**VILLAGE OF BARTLETT
PLAN COMMISSION
(HYBRID MEETING)
AGENDA**

**BARTLETT MUNICIPAL CENTER
228 S. MAIN STREET
November 12, 2020
7:00 P.M.**

DATE: November 6, 2020
TO: The Chairman and Members of the Plan Commission
FROM: Kristy Stone, Village Planner 
RE: **(#20-02) Rana Cold Storage**

DATE: November 6, 2020
TO: The Chairman and Members of the Plan Commission
FROM: Kristy Stone, Village Planner *KS*
RE: **(#20-08) Bucky's on Stearns**

Demolition Plan with Environmental Conditions Overlay
 Bucky's
 SWIC IL 59 & Stearns
 Bartlett, Illinois

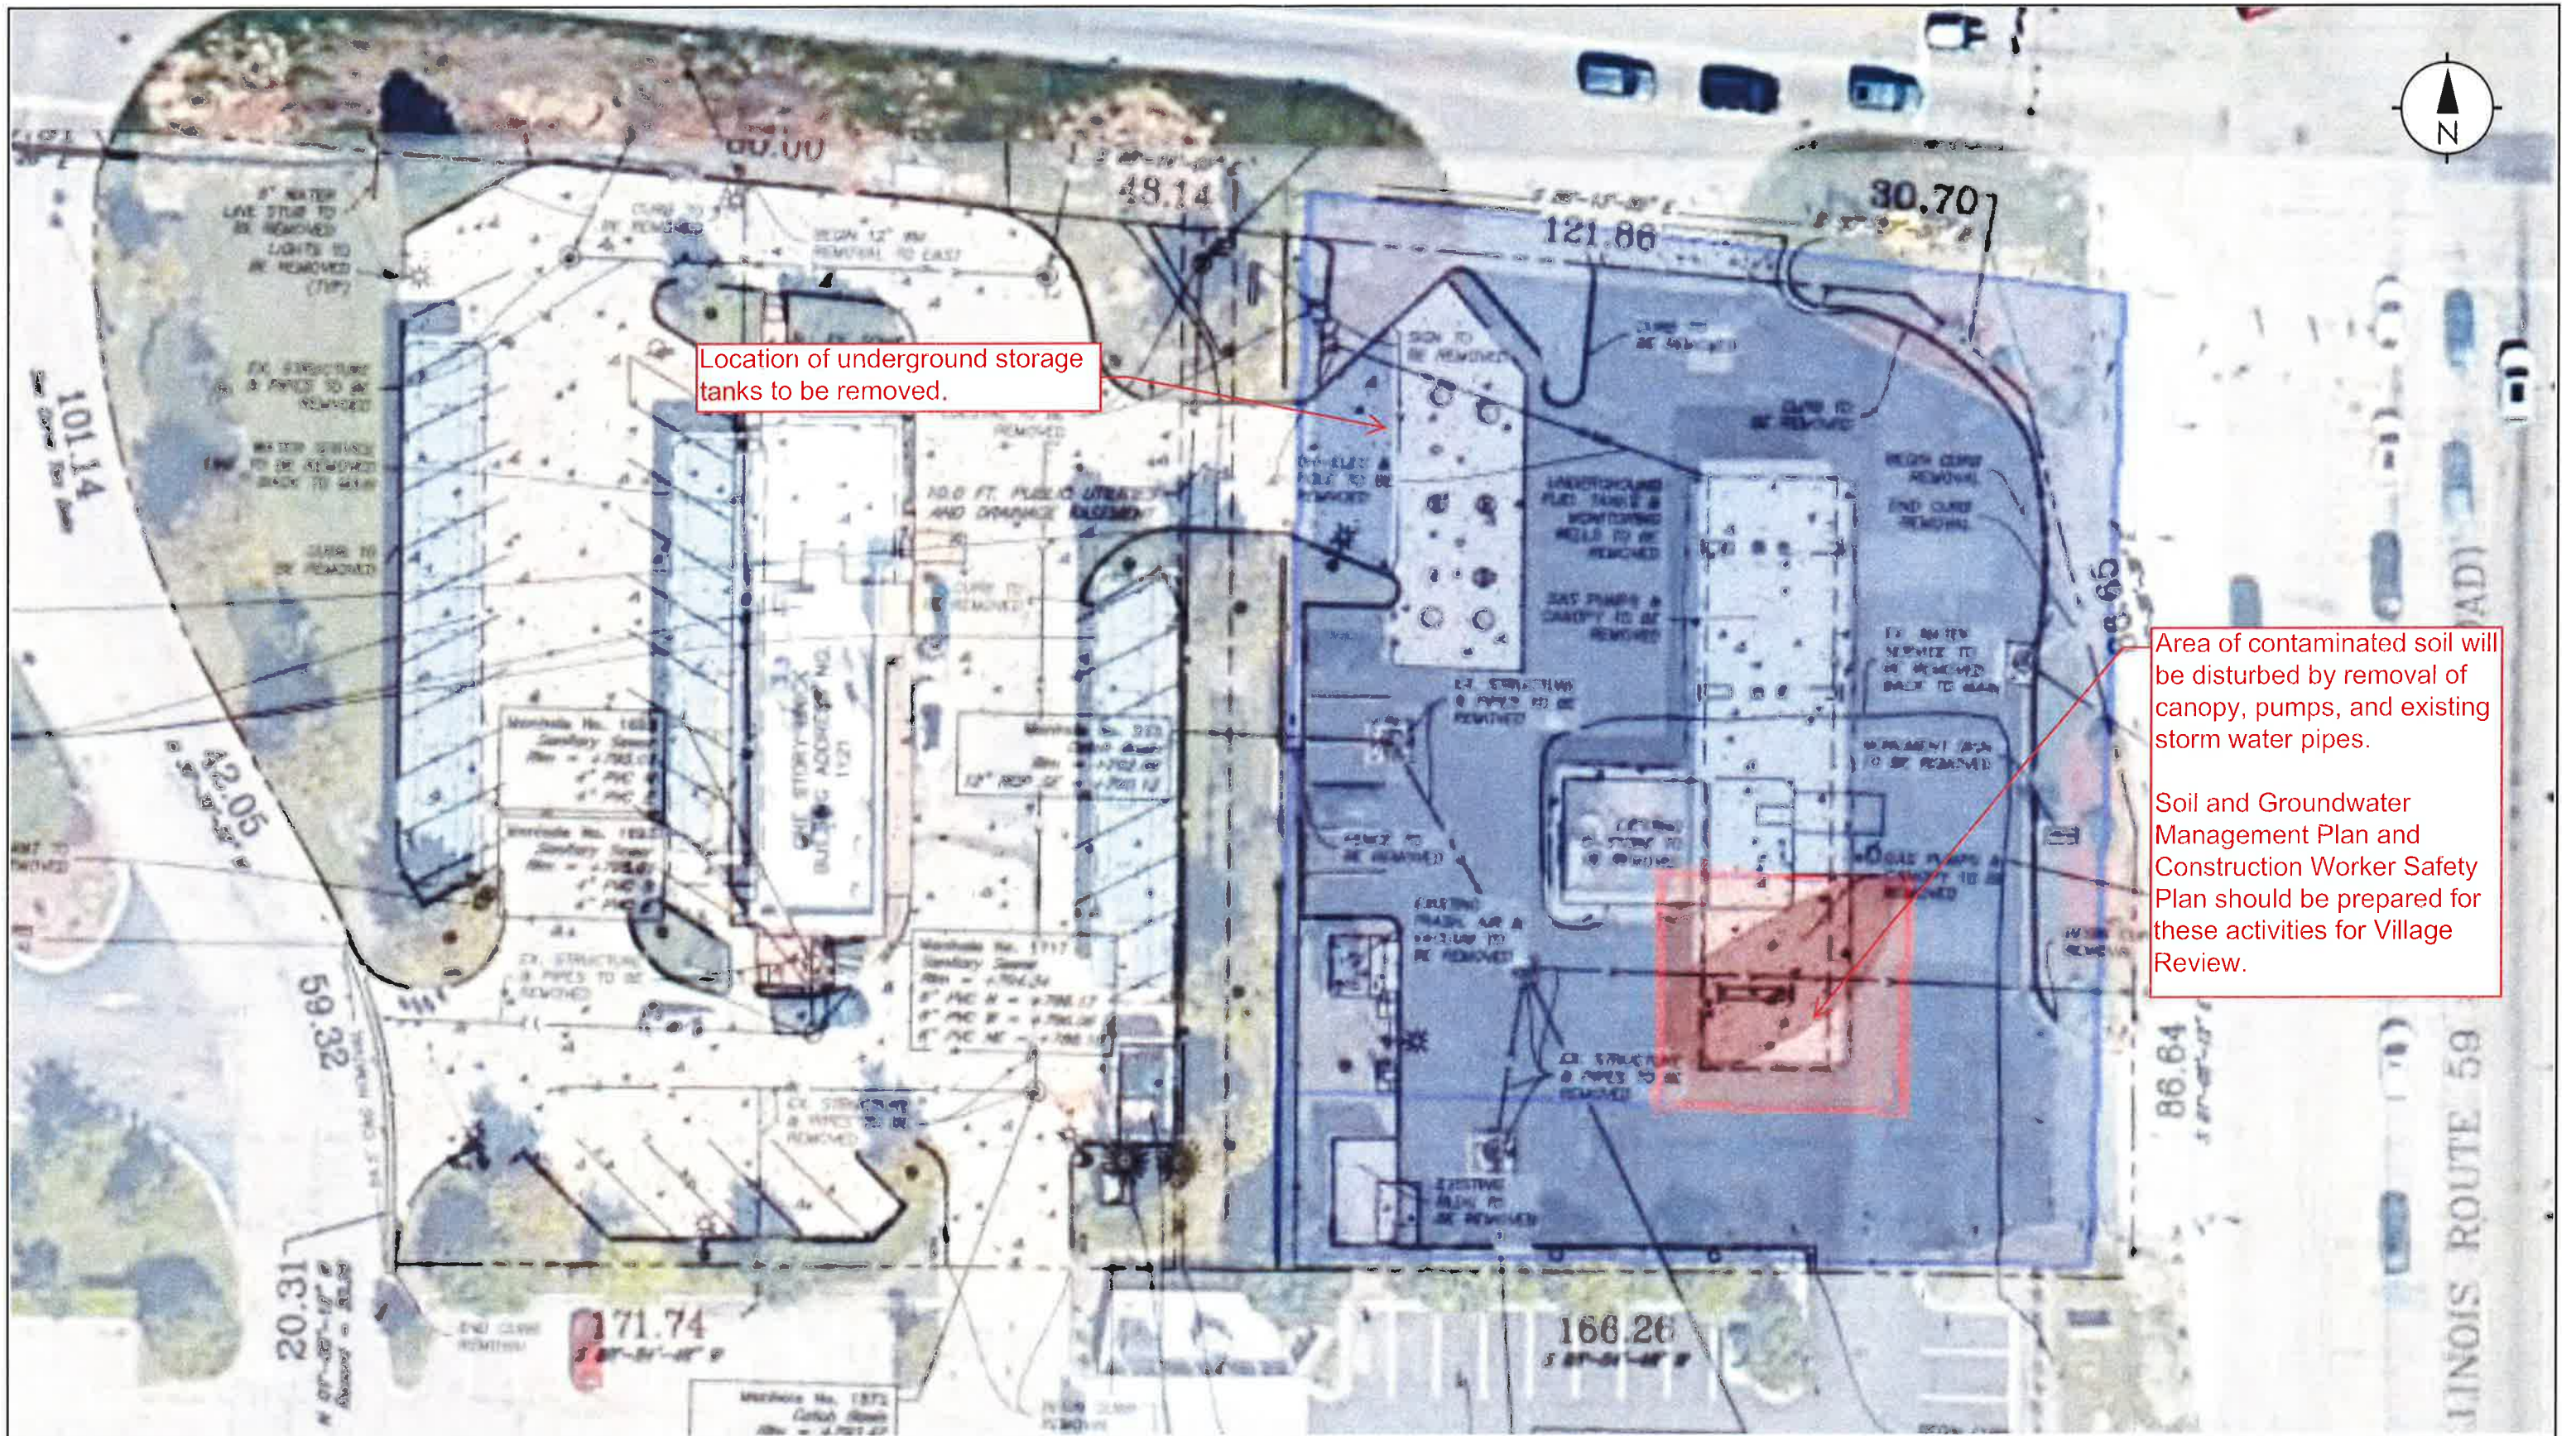
Proposed Site Development Work	Comments by Village of Bartlett's Environmental Consultant	Site Plan	Applicable information in NFR Letter
Removal of existing underground storage tanks	The developer should provide a proposed plan and schedule for removal of the existing UST System and related dispenser piping as it relates to redevelopment schedule. This UST removal may determine that a new petroleum release may have occurred and require corrective action prior to or during the proposed Bucky's Development. The developer shall notify the Village if a new LUST incident is determined during UST removals. This may warrant additional review/comment related to the planned development.	Refer to the Demolition Plan, Figure 1	Page 4
Demolition within areas of existing petroleum contamination defined in NFR.	Utilities and a portion of the new canopy run through an area of the site requiring an engineered barrier per the NFR. Area of contaminated soil will be disturbed by removal of the canopy, pumps, and existing storm water pipes.	Refer to the Demolition Plan, Figure 1	Page 3 & Page 4

<p>Petroleum-contaminated Groundwater Management during excavations</p>	<p>Due to the property having a groundwater use restriction and the potential for groundwater contamination, we recommend having a Groundwater Management Plan and Construction Worker Safety Plan in place for these activities if groundwater is encountered during excavation.</p>	<p>Refer to the Demolition Plan, Figure 1</p>	<p>Page 3</p>

Location of underground storage tanks to be removed.

Soil and Groundwater Management Plan and Construction Worker Safety Plan should be prepared for these activities for Village Review.

Utility Plan with Environmental Conditions Overlay
 Bucky's
 SWIC IL 59 & Stearns
 Bartlett, Illinois

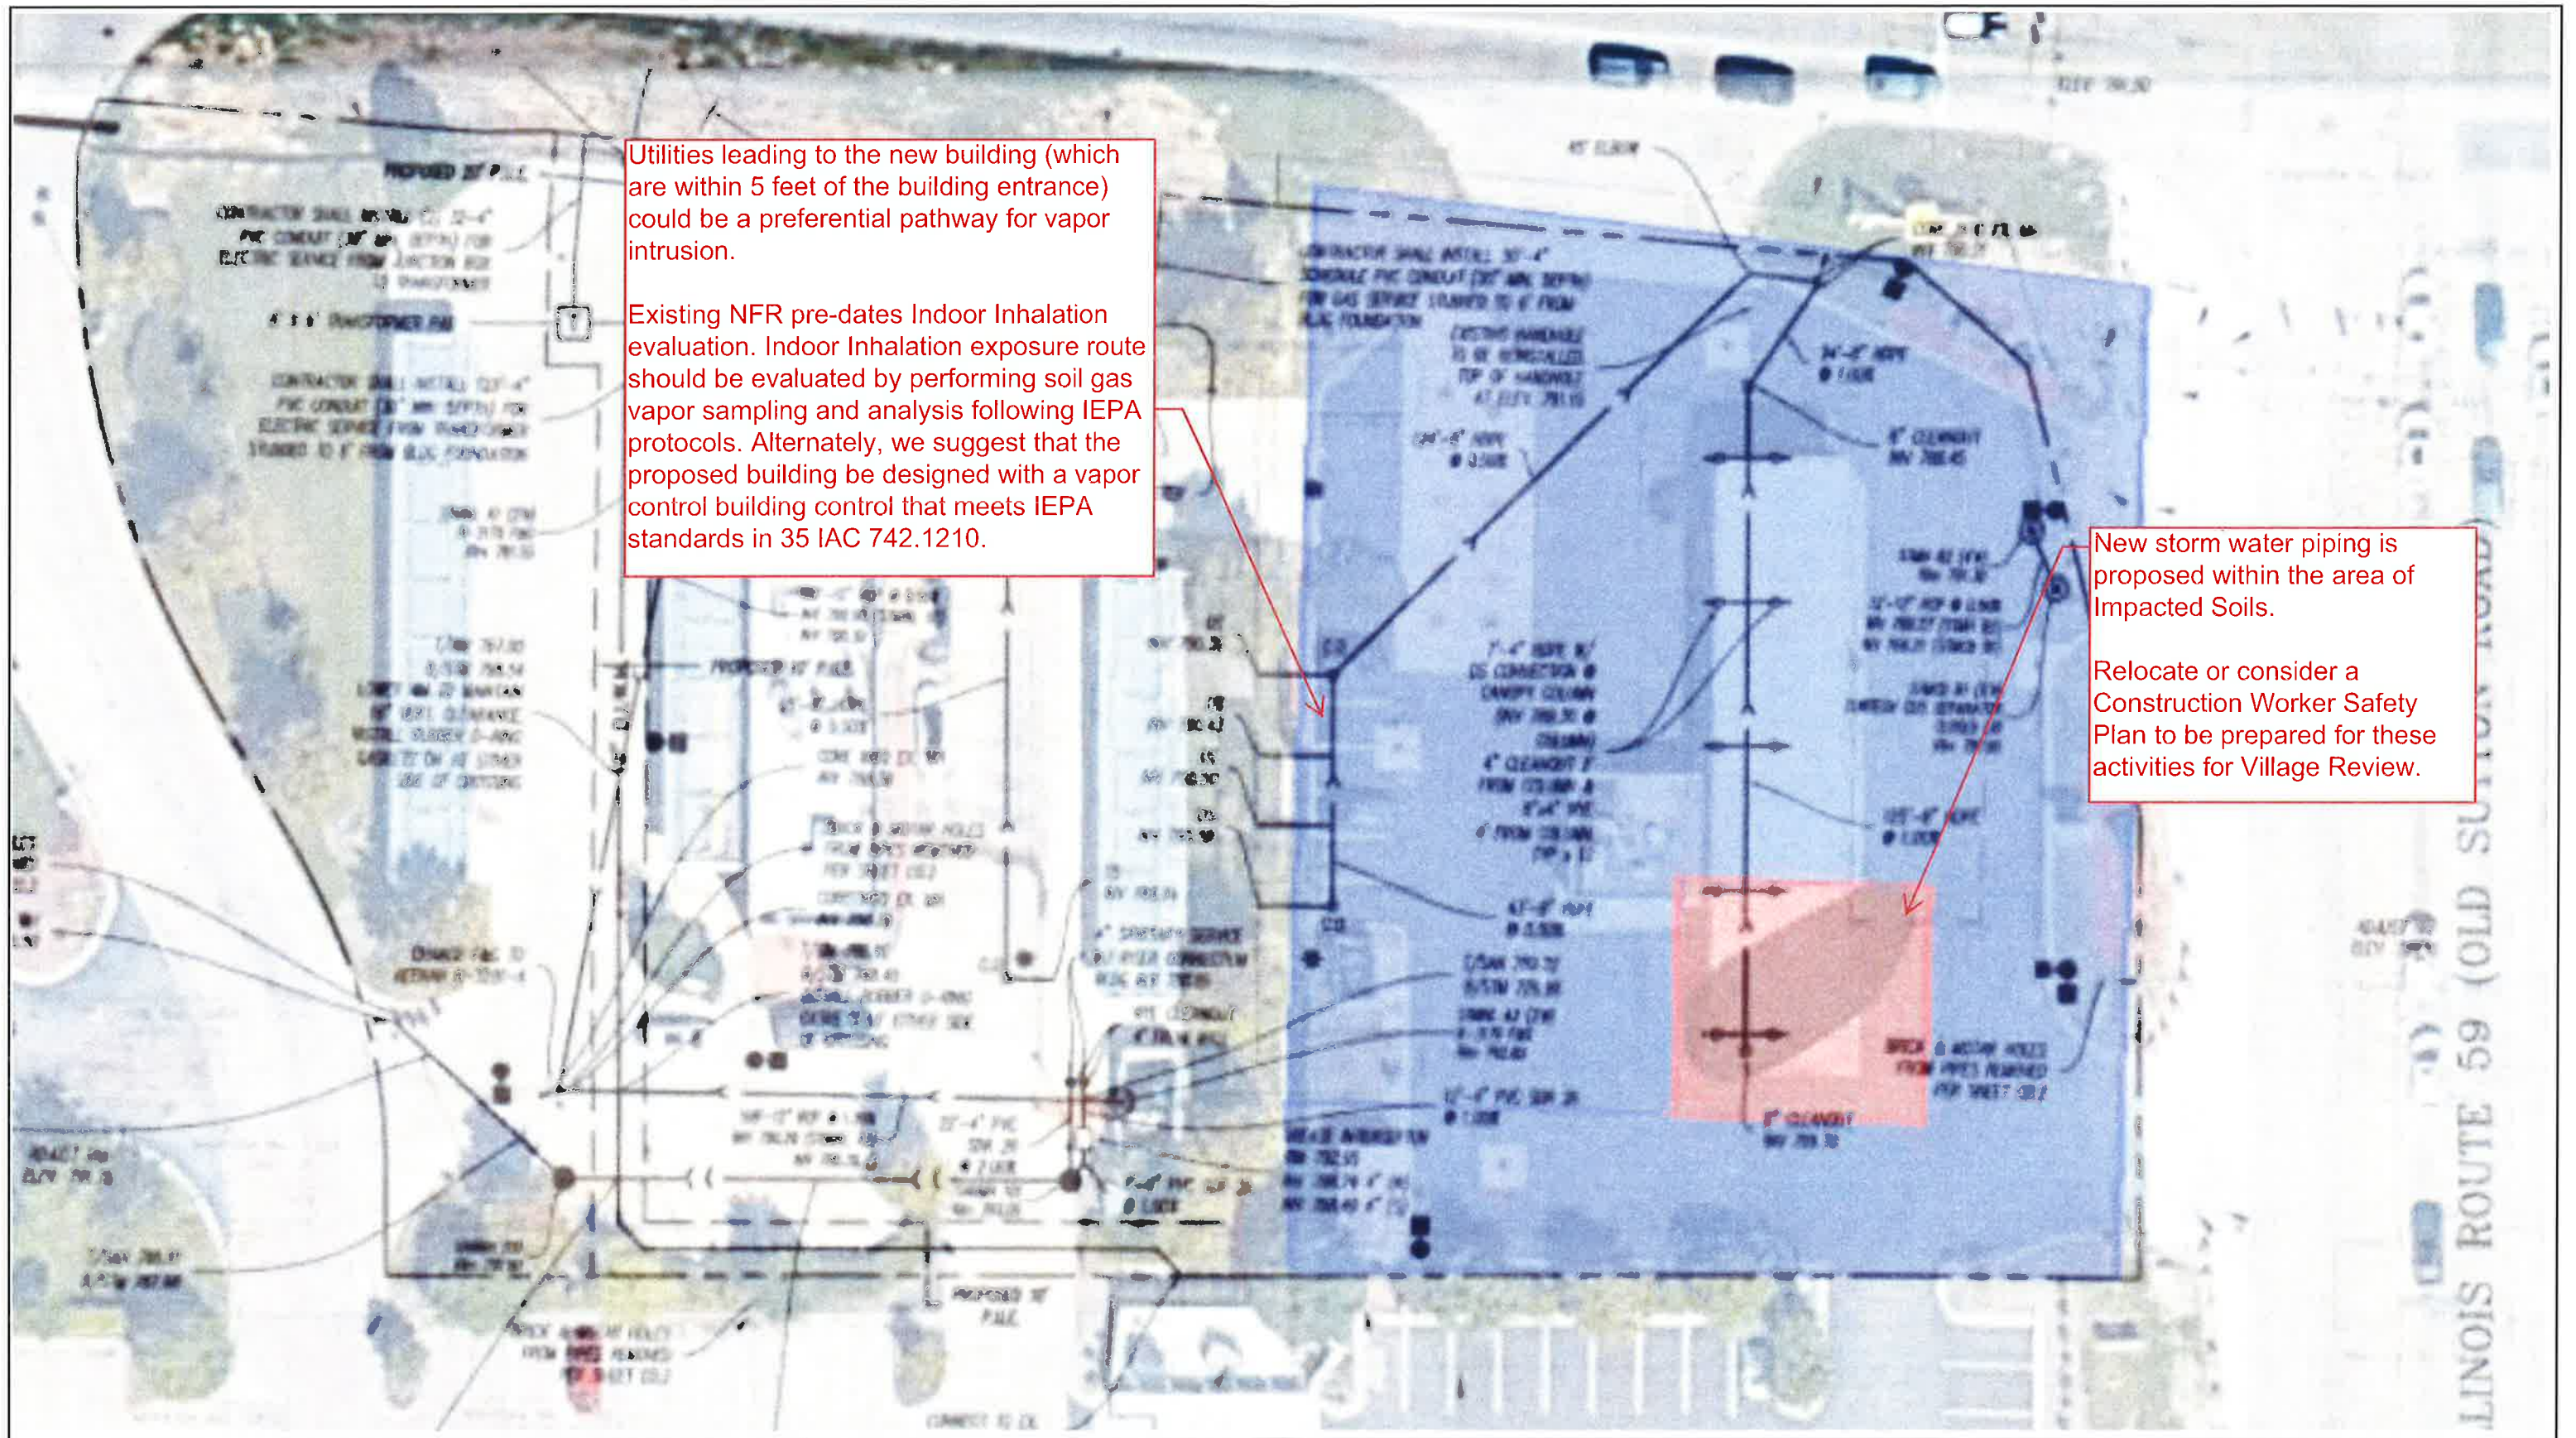
<p>According to the 2007 documentation (August 14, 2007, Corrective Action Plan), Xylenes (indicative of petroleum contamination) exceed Tier 1 Construction Worker Inhalation Remediation Objectives. We advise implementing a Soil and Groundwater Management Plan and Construction Worker Safety Plan for these demolition/removal activities and submitted for Village review.</p> <p>Depending on the excavation plan, remove and haul could be an option for contaminated soil, ultimately no longer requiring an engineered barrier (Updated NFR would be required).</p>		
<p>Utility Installation</p>	<p>Utilities leading to the new building (which are within 5 feet of the building entrance) could be a preferential pathway for vapor intrusion. The existing NFR pre-dates current regulations for protecting buildings and structures from an indoor inhalation pathway. Indoor Inhalation exposure routes should be evaluated by performing soil gas vapor sampling and analysis following IEPA protocols. Alternately, we suggest that the proposed building be designed with a vapor control building control that meets IEPA standards in 35 IAC 742.1210 (Appendix B).</p> <p>New storm water piping and canopy foundations are proposed to be constructed within the area of petroleum contaminated soil and groundwater. If feasible, we recommend that subsurface stormwater controls and structures be located outside of the boundary of petroleum contamination. If not feasible, we recommend that storm water piping and structures be designed to prevent inflow/infiltration of petroleum contaminated groundwater and vapor. One approach is to place a bentonite-mat GCL material in sewer trenches. A Soil and Groundwater Management Plan and Construction Worker Safety Plan should be prepared for these activities and submitted for Village review.</p>	<p>Refer to the Utility Plan & Site Plan, Figure 2 & Figure 3</p>

Utilities leading to the new building (which are within 5 feet of the building entrance) could be a preferential pathway for vapor intrusion.

Relocate or consider a Construction Worker Safety Plan to be prepared for these activities for Village Review.
